AGGARWAL KAMIKAZES

PROJECT
AKCC-2026-0017

Site	1450 Industrial Way, Burnaby BC	Equipment	GSSI StructureScan Mini XT
Client	Pinnacle Structural Eng.	Slab type	200 mm two-way, post-tensioned
Structure	Level-2 parkade suspended deck	Coverage	3 grids · 6.2 m ²
Scan date	2026-05-28	Project no.	AKCC-2026-0017

MARKED-UP LAYOUT

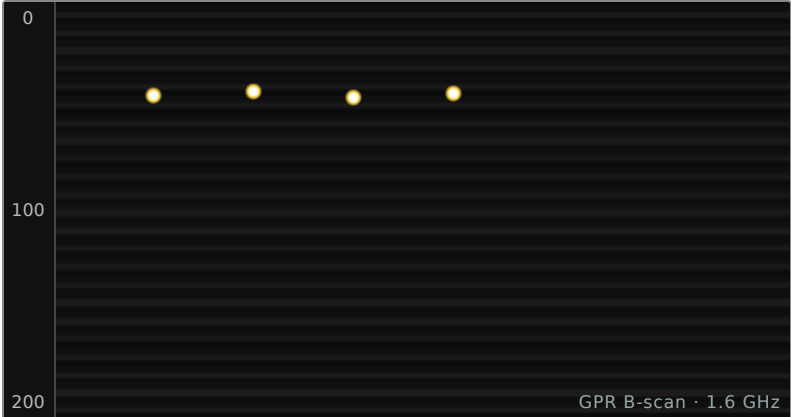
CORE	SIZE	VERDICT	CLEARANCE & RECOMMENDATION
A	4"	SAFE	60 mm clear of all targets. Cleared to drill as marked.
B	6"	CAUTION	PT tendon within 25 mm — relocate 75 mm south and re-scan before drilling.
C	4"	NO-GO	Directly over conduit run. Do not drill; redesign required.

All targets were chalk-marked on the slab in the legend colours below. Proposed core centres are marked with their letter and verdict. A photographic record of each marked grid is included on the following pages.
